ADDENDUM NO. 3

RFP #22-53

Valve and Finished Water Tank & Reservoir Improvements

The following changes, additions, and/or deletions shall be made to the Request for Proposal (RFP) for Water Treatment Service Unit – Valve and Finished Water Tank & Reservoir Improvements, RFP #22-53.

RAILING POST CONNECTION DETAIL
NO SCALE

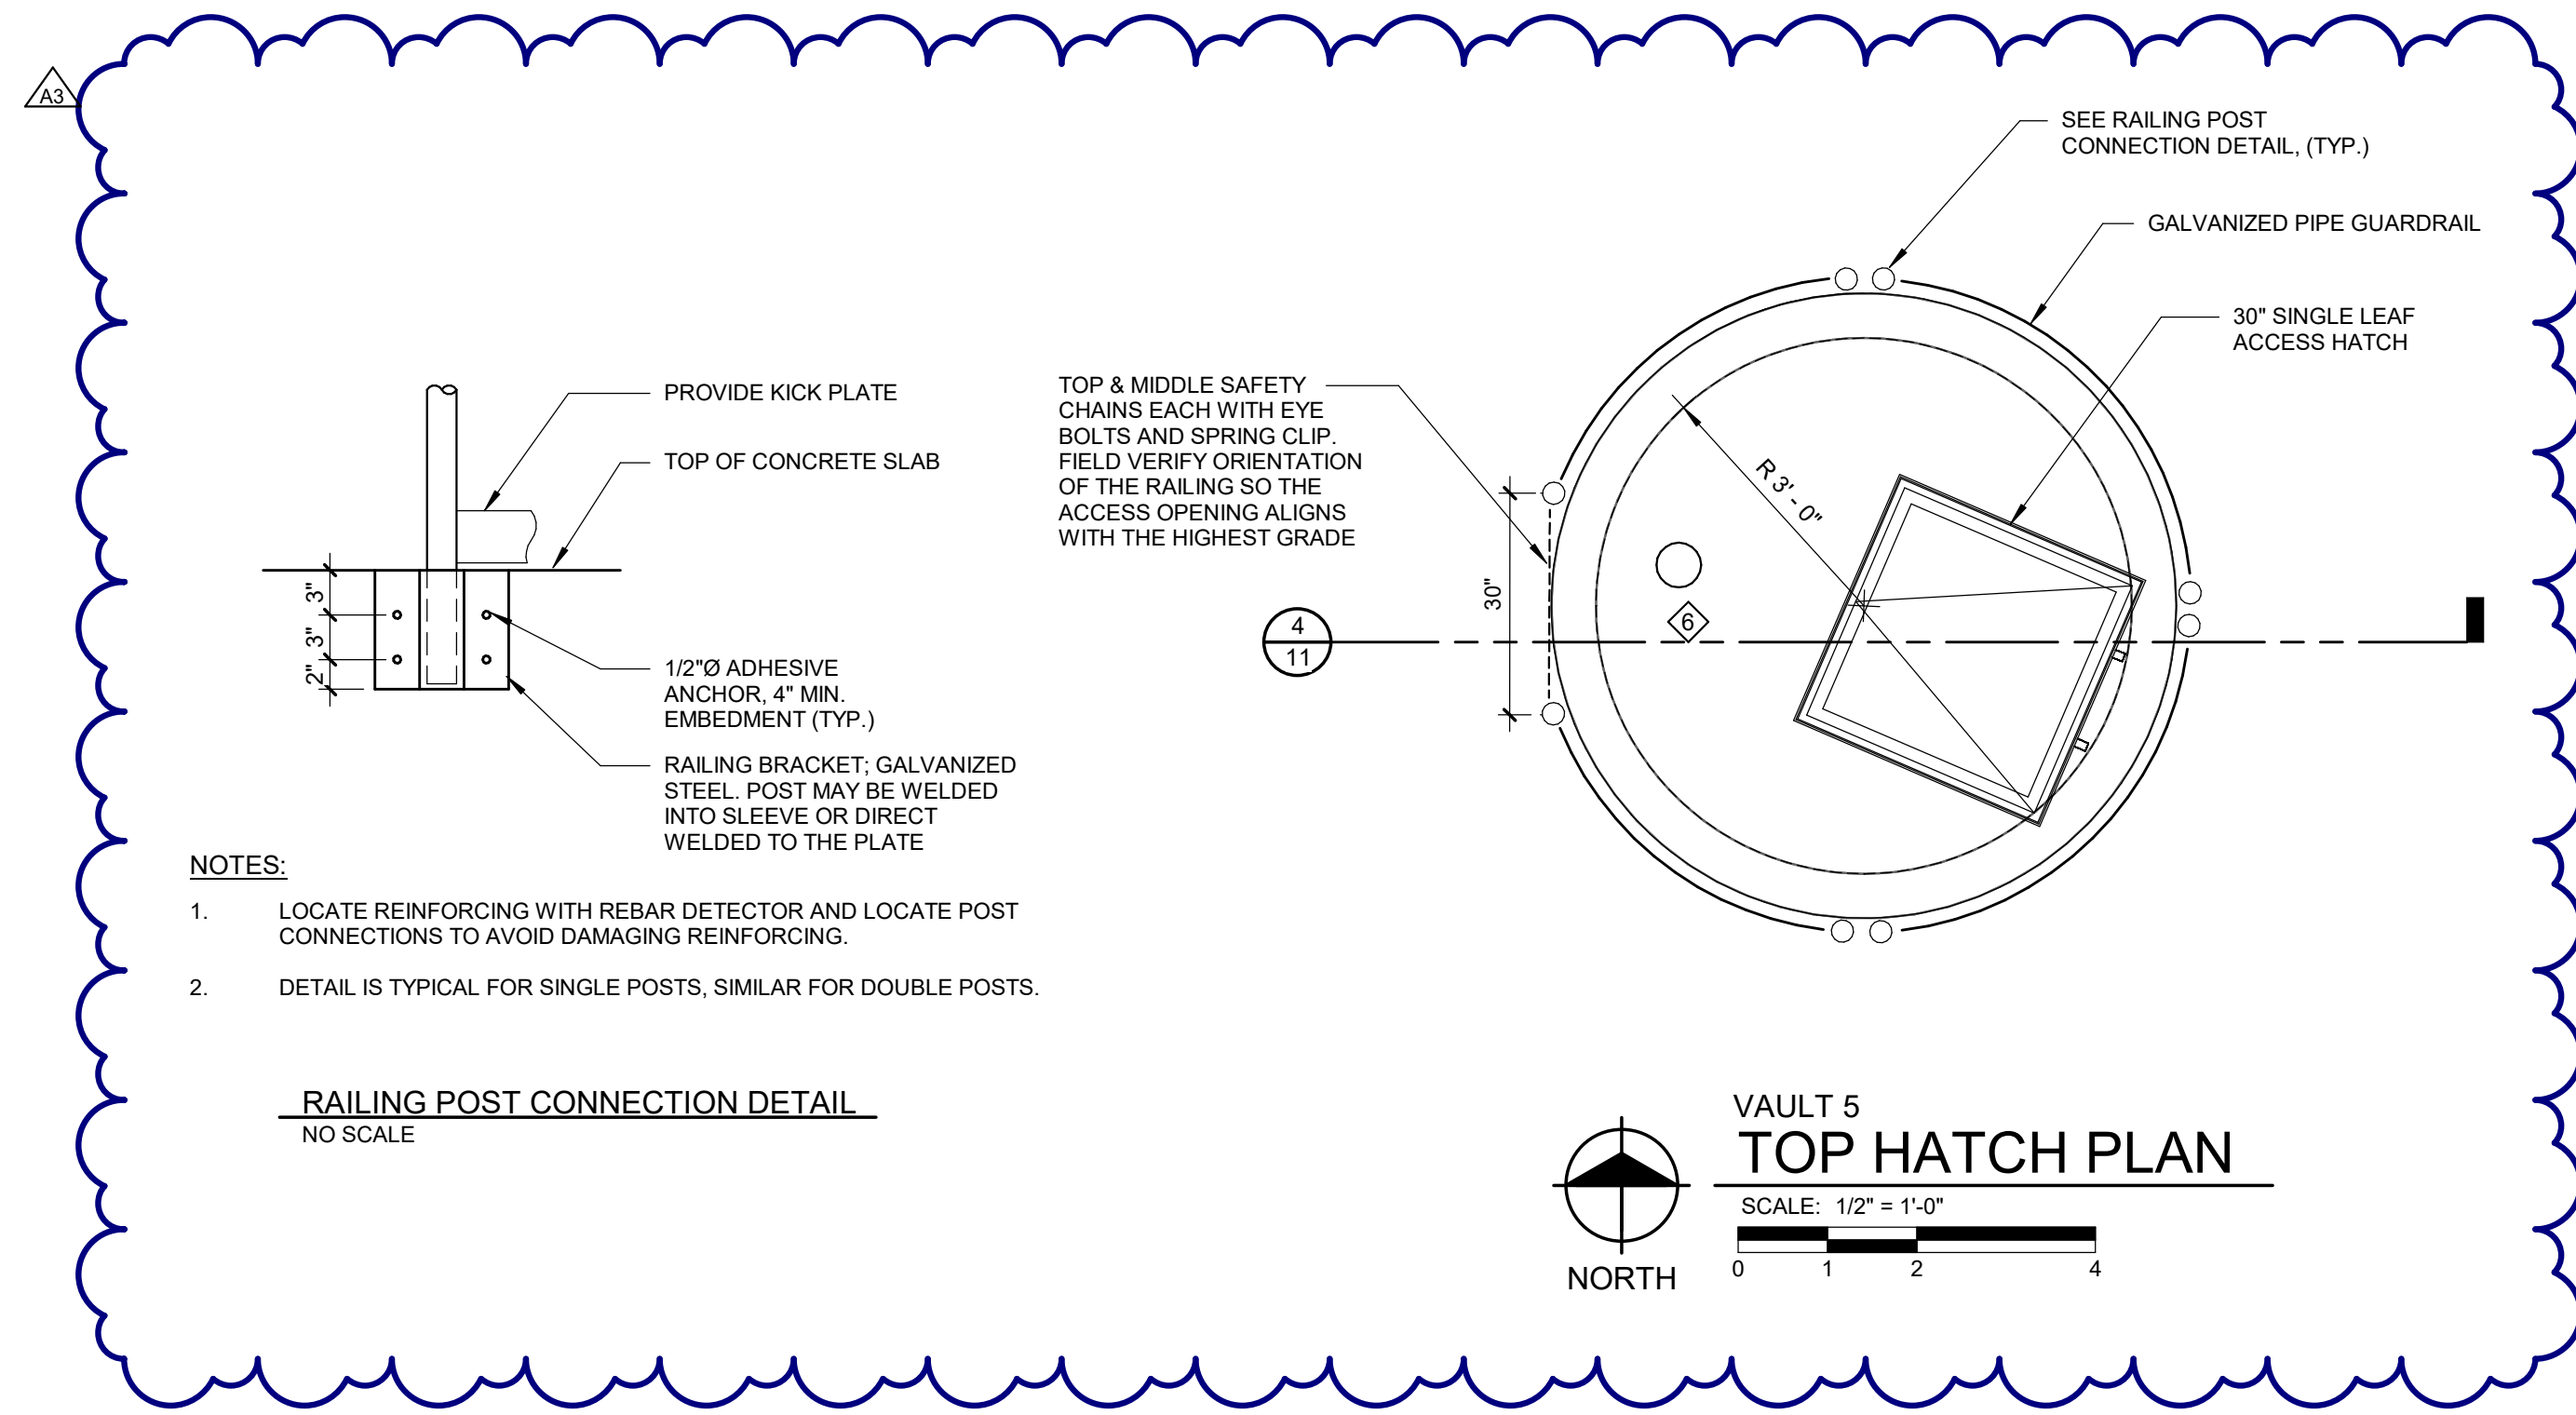
- a. Smoothly curve railing to match the exterior diameter of the vault.
 - 4. Close exposed ends of steel pipe by welding 3/16-inch thick steel plate in place or use prefabricated fittings.

- 5. Guardrail:
 - a. 42 inches high above working surface.
 - b. Two rails, one at top and one at mid-height.
 - 6. Access Opening: Provide 30-inch wide gap in railing assembly for access.

- 8. Post Spacing:
 - a. 6 feet maximum.
 - b. Space post evenly around the perimeter of the vault.
 - 9. Provide 1/4-inch toe plate 4 inches higher than working surface, smoothly curved to match curvature of railing.

WTP RESERVOIR SITE PLAN
SCALE: 1" = 40'
0 20 40 80

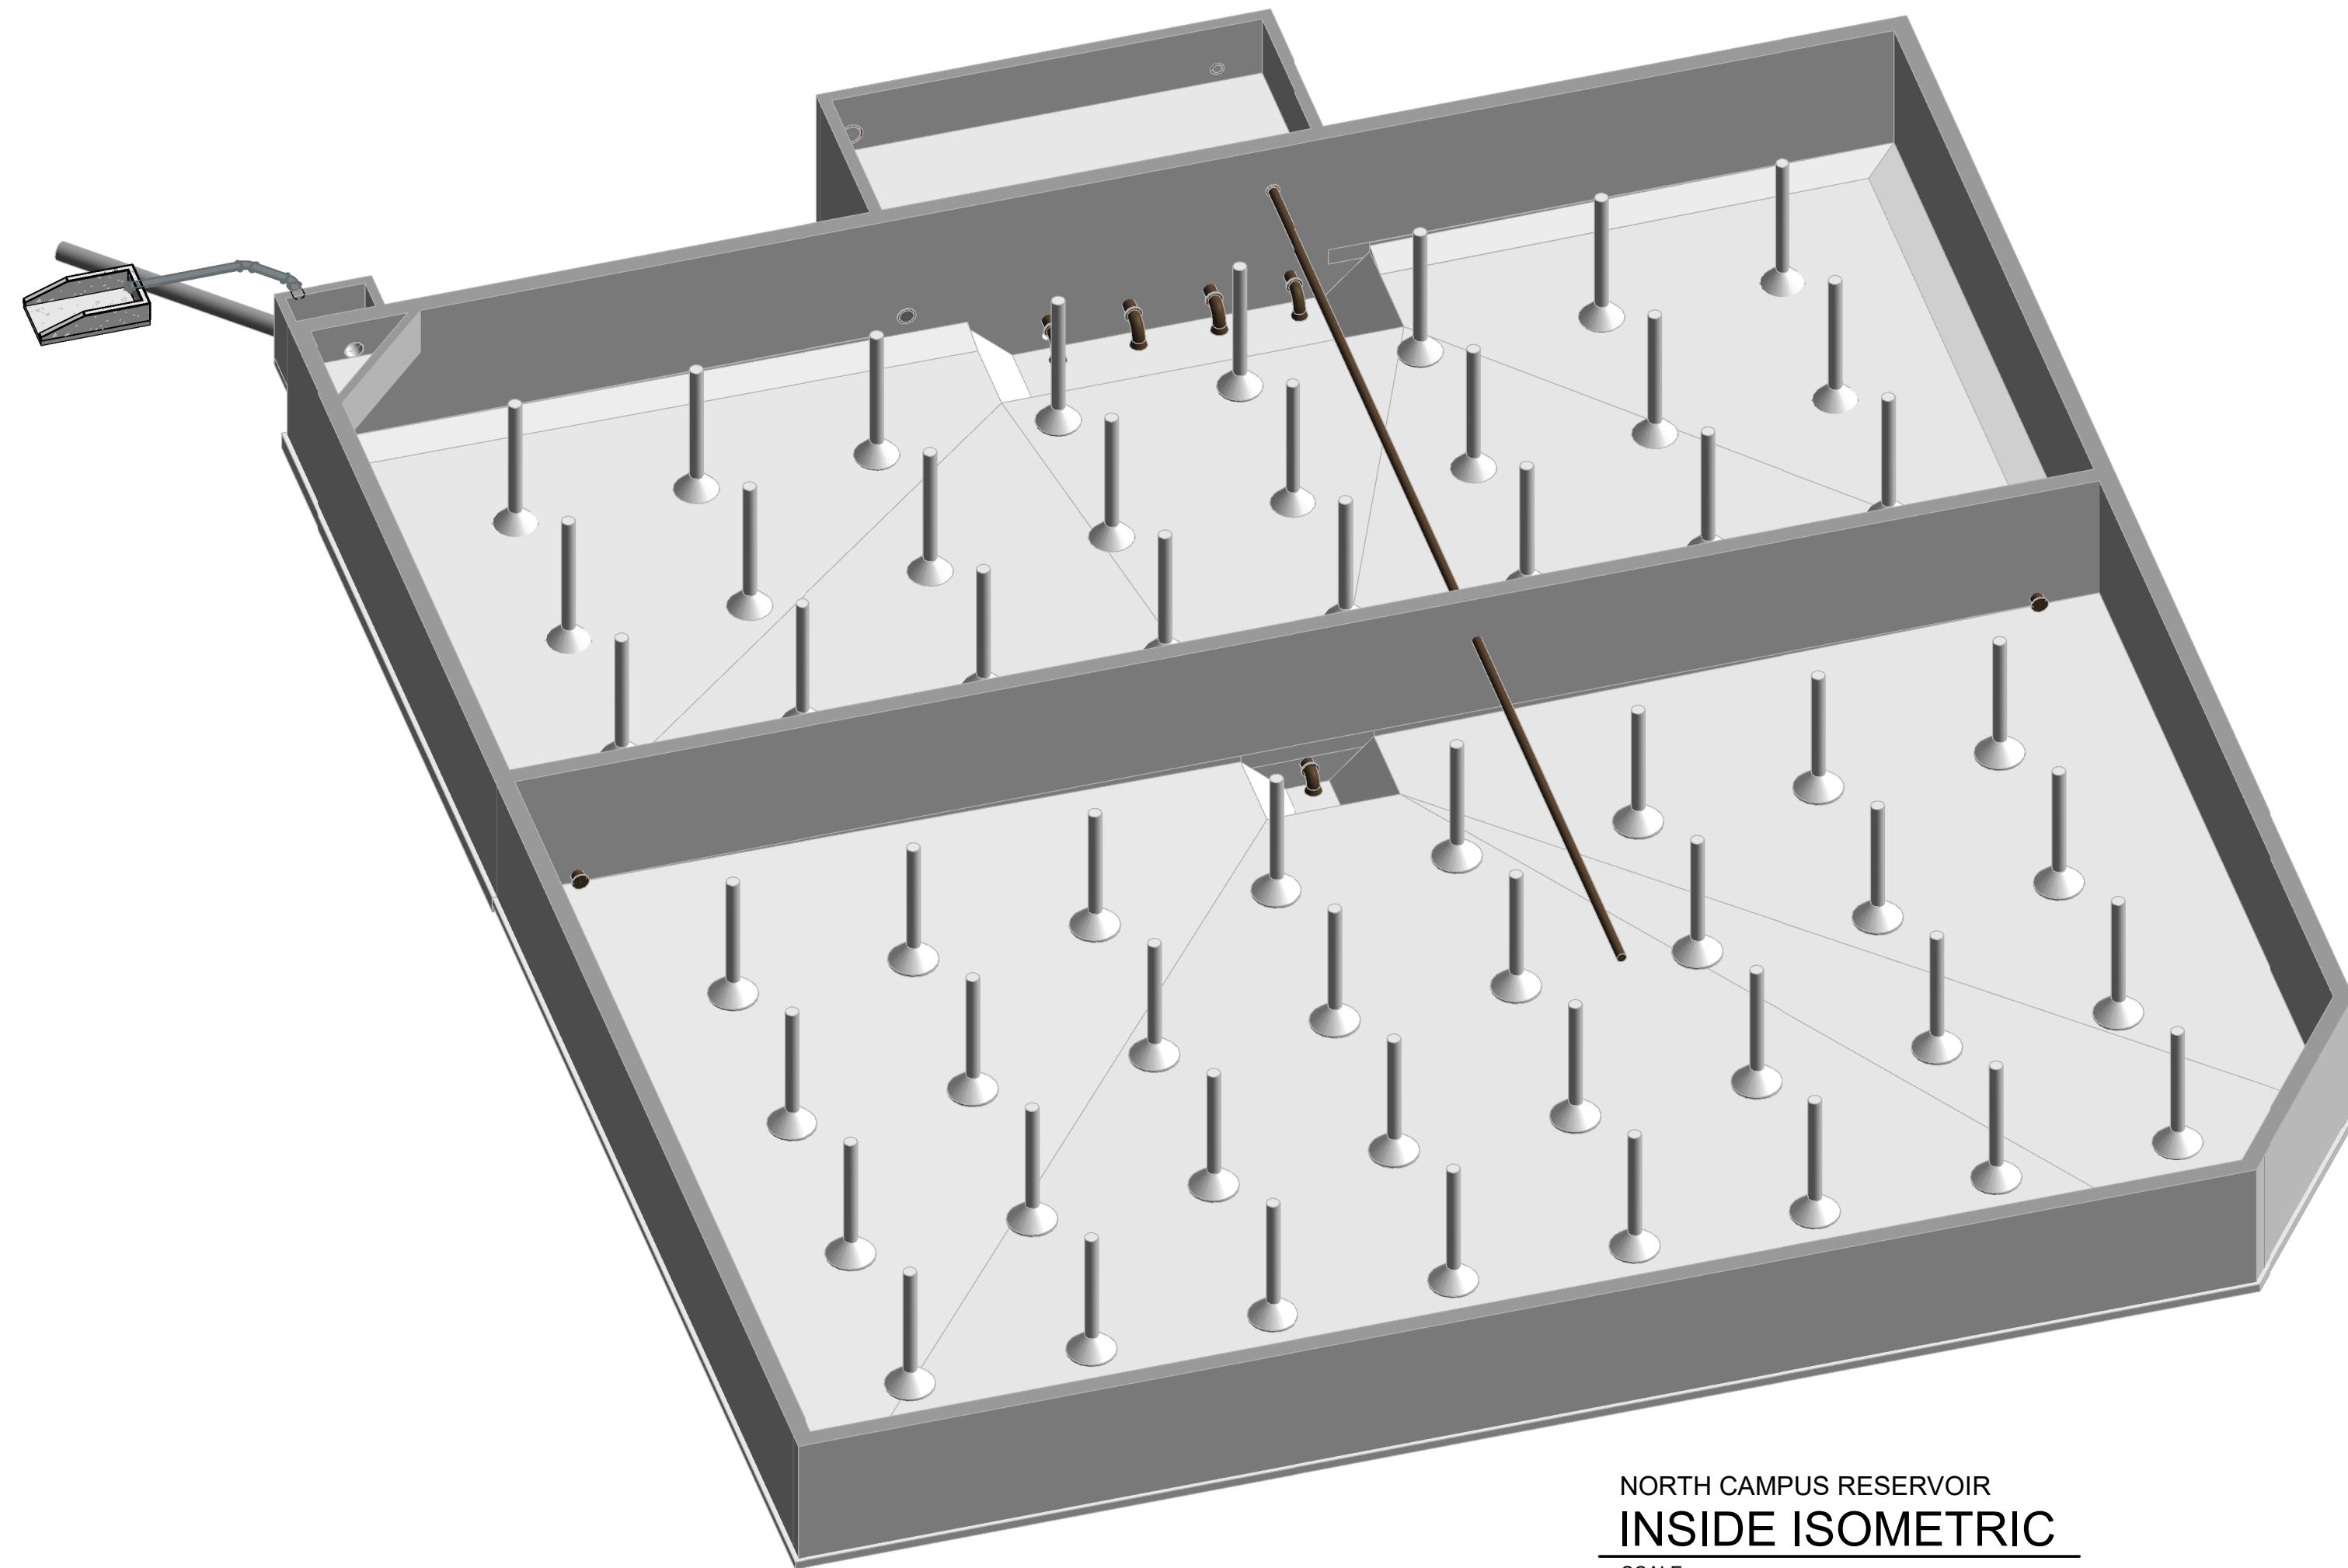
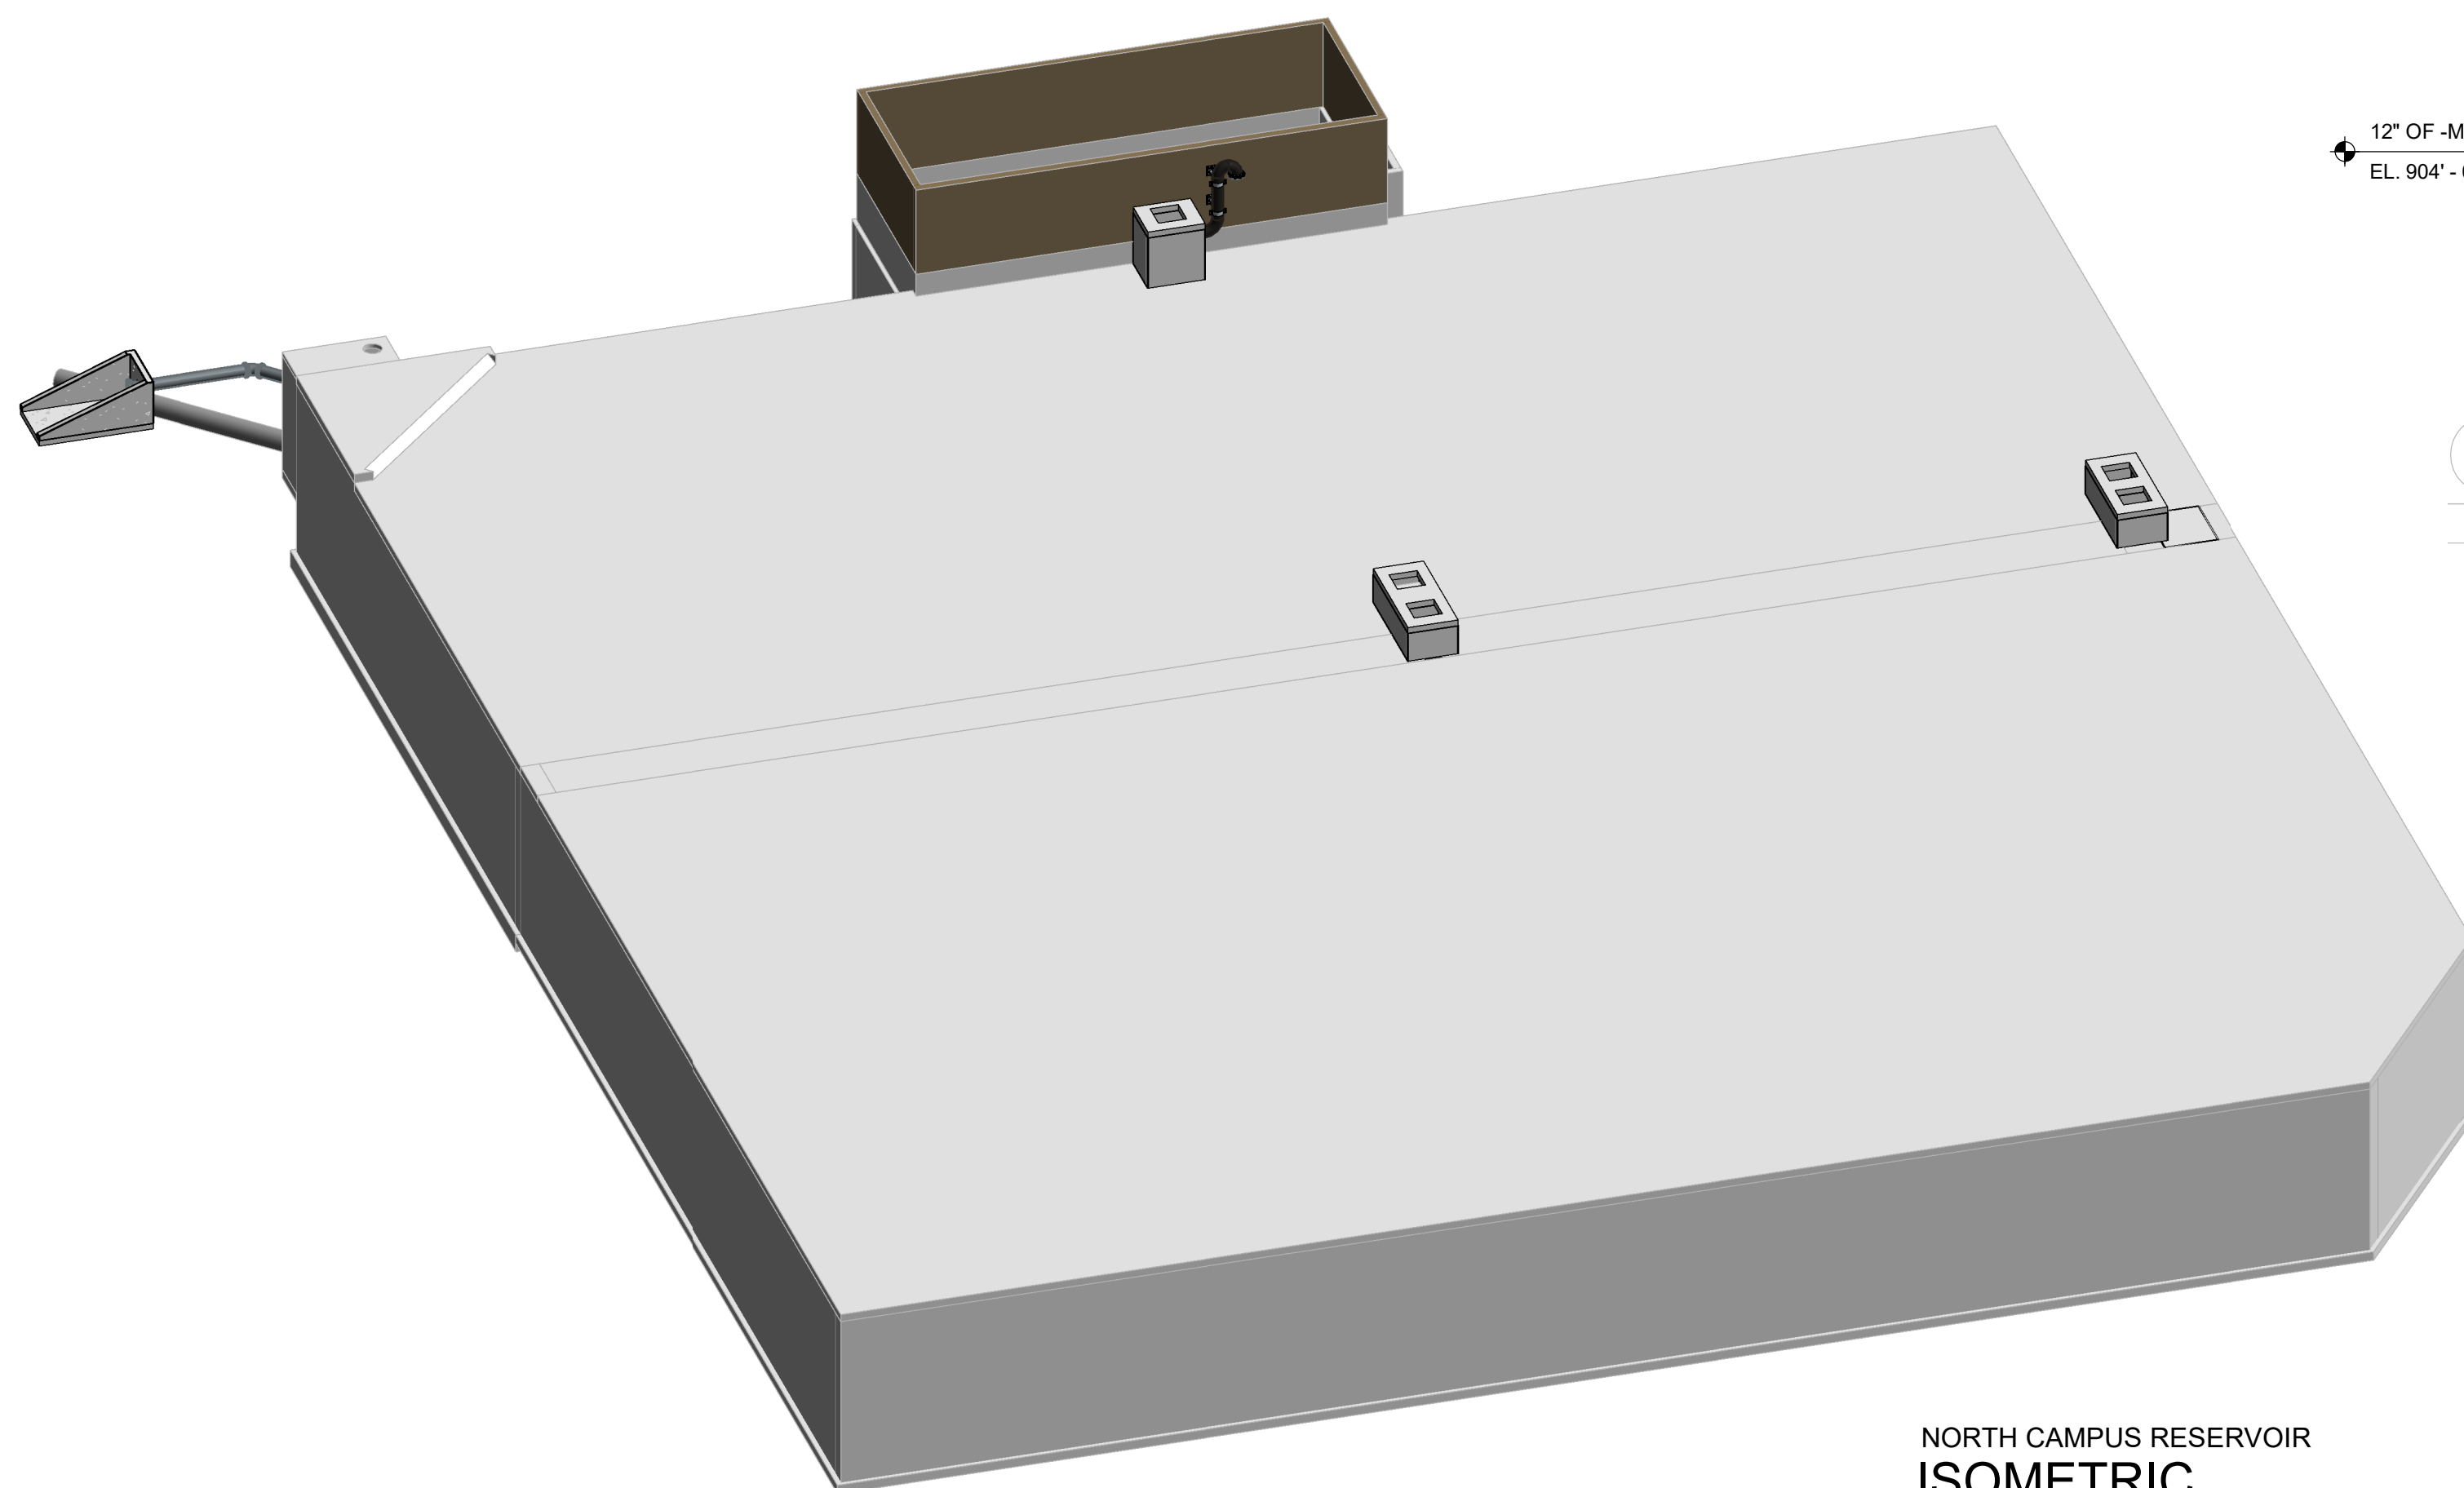
- H. Alternate #8:
 - 1. **Install New Reservoir Access Hatches:**
 - a. Base Bid #1 does not include a pay item for Install New Reservoir Access Hatches as indicated on Sheets 16 and 30.
 - b. Add Item “Alternate #8 – Install New Reservoir Access Hatches” to Base Bid #5 as specified in Division 01 Section “Unit Prices – Measurement and Payment” and as indicated on Sheets 16 and 30.

- INSTALL NEW RESERVOIR ACCESS HATCH PER DETAIL ON SHEET 30.
